10th January 2018

Our ref. G1701/18A10/AK1

Planning Application 2016/1639/P - 23 Crossfield Road NW3 4NU

Secant solid wall arrangement Contiguous spaced arrangement

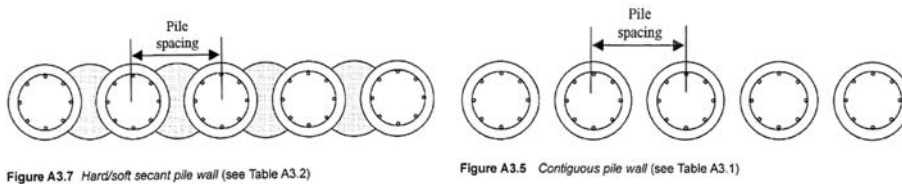
In support of the revised submission GEA opined that their value for pre-existing ground pressures was reasonable. I agree with that insofar as assessment of the movement caused by the basement excavation is concerned. Those pressures are relieved and cause ground movement as the piled wall is installed.

But no account has been taken by GEA of installation movement and, as I pointed out in November, the movement caused by insertion of a secant wall is likely to be about twice as much as that due to a contiguous pile arrangement. Also, water pressure on the wall arising from ground movement has been specifically and quite wrongly excluded from the retaining wall analysis, and a decimal point error within the computer input has caused the top temporary strut to be calculated to have 10 times the resistance to movement that it would really exert. The analysis is not satisfactory.
